ADDENDUM 1

Date: July 29, 2025

Re: UNC Pembroke – Business Administration Building Demolition  
SCO ID: 23-27505-02A  
JPA Project #: 23PEM345

The following items are intended to revise and clarify the Drawings and the Project Manual.

AD101

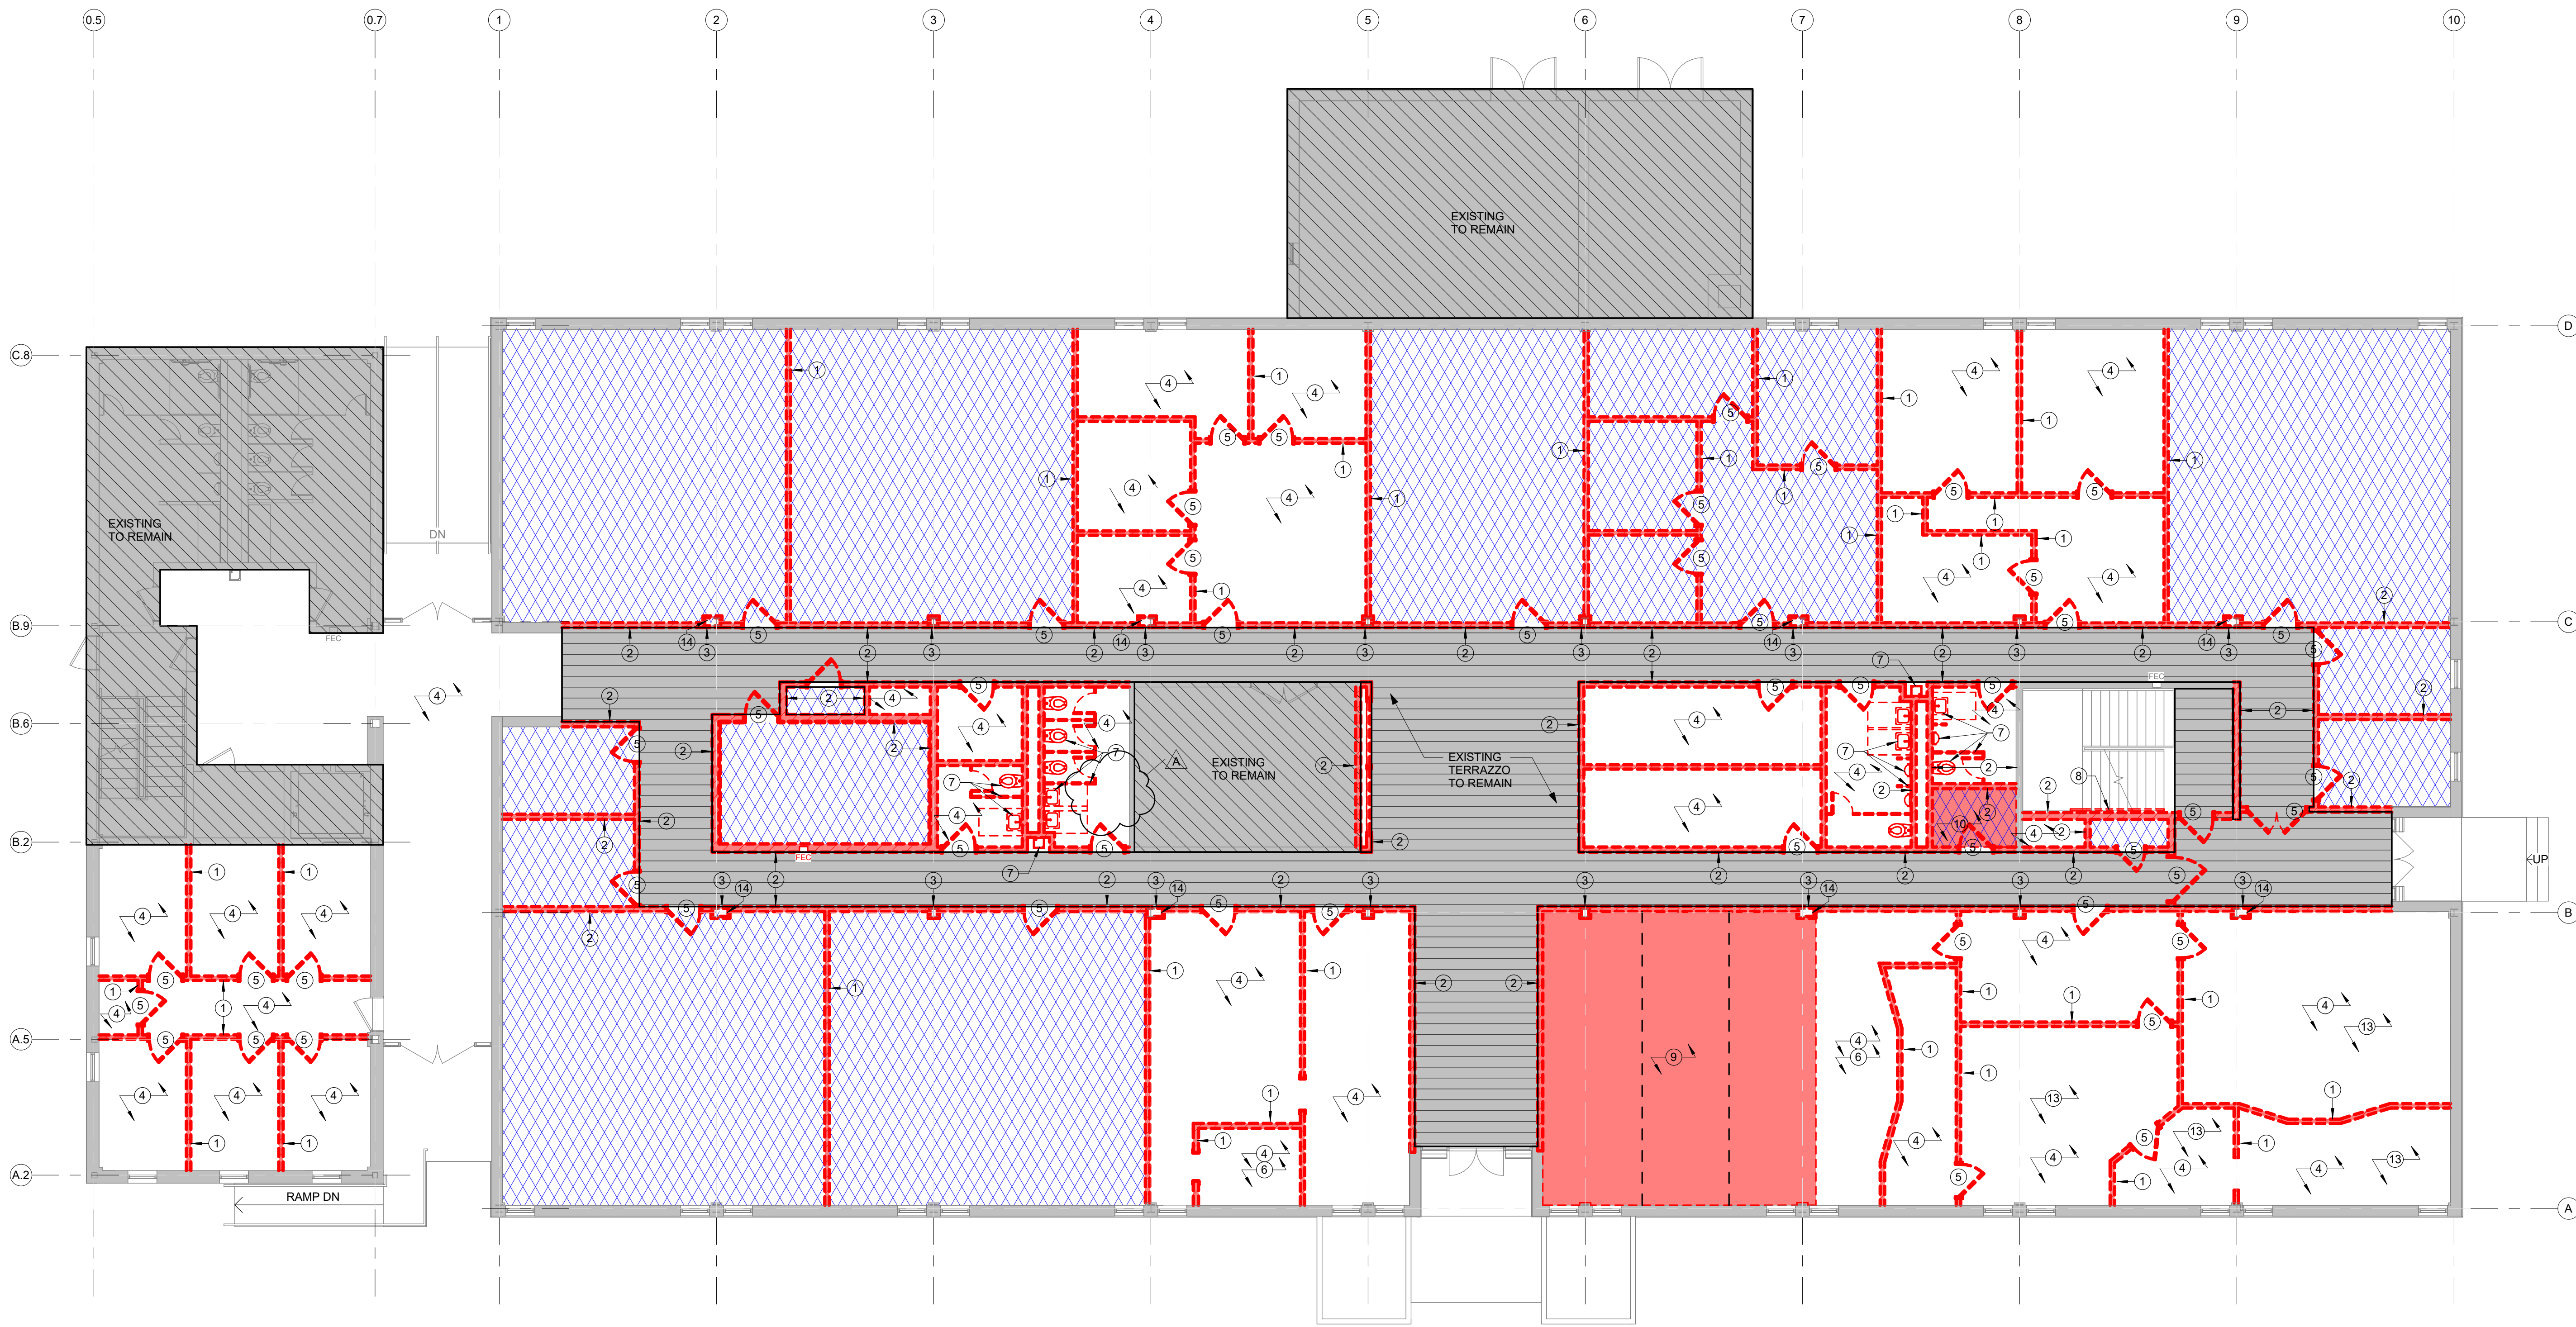
**Item 5.** SHEET AD101 & AD102: Removed Key Note 11 requesting that stone toilet partitions be salvaged. Toilet partitions are to be demolished.

**TD101**

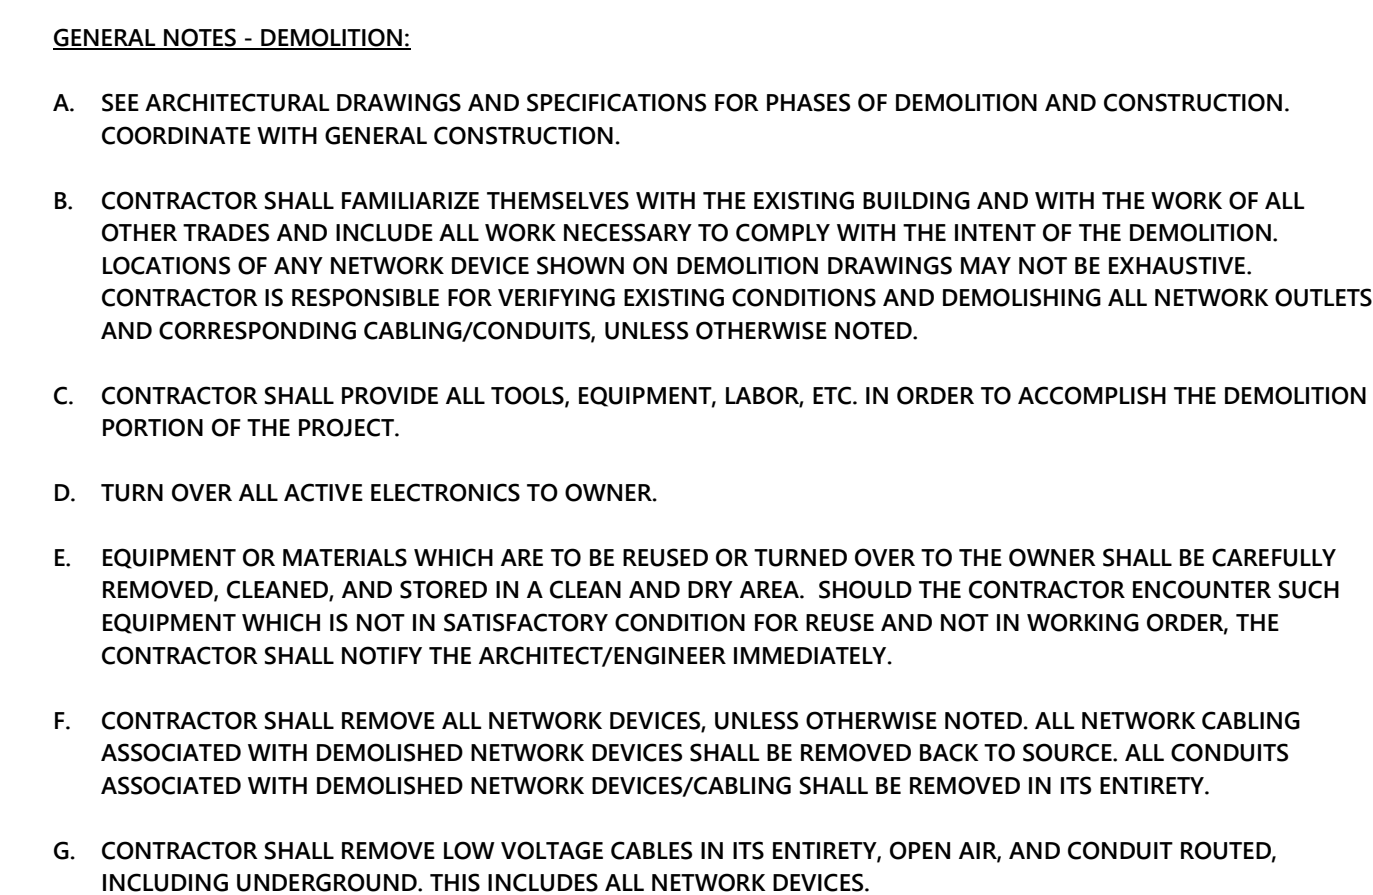
**Item 6.** SHEET TD101: Added note “Remove data box and coax cables from Level 1 Mechanical Room.”  
See revised sheet for complete information.

1. CONTRACTOR SHALL REMOVE, CLEAN, AND RETURN EXISTING CAMERA TO NETWORK ADMINISTRATOR.
2. EXISTING ALERTUS HEAD-END SHALL BE REUSED AND RELOCATED TO NEW IT ROOM 1B3. CONTRACTOR SHALL REMOVE AND STORE IT SECURE PLACE UNTIL ARTIST ALLOCATION.
3. CONTRACTOR SHALL REMOVE EXISTING TERMINAL BLOCKS AND ALL ASSOCIATED CABLING/CONDUIT/PANELS IN ITS ENTIRETY. COORDINATE WITH UNCP DOT PRIOR TO REMOVAL.
4. CONTRACTOR SHALL REMOVE EXISTING COAX CABLING AND ASSOCIATED HARDWARE IN ITS ENTIRETY. COORDINATE WITH UNCP DOT PRIOR TO REMOVAL.
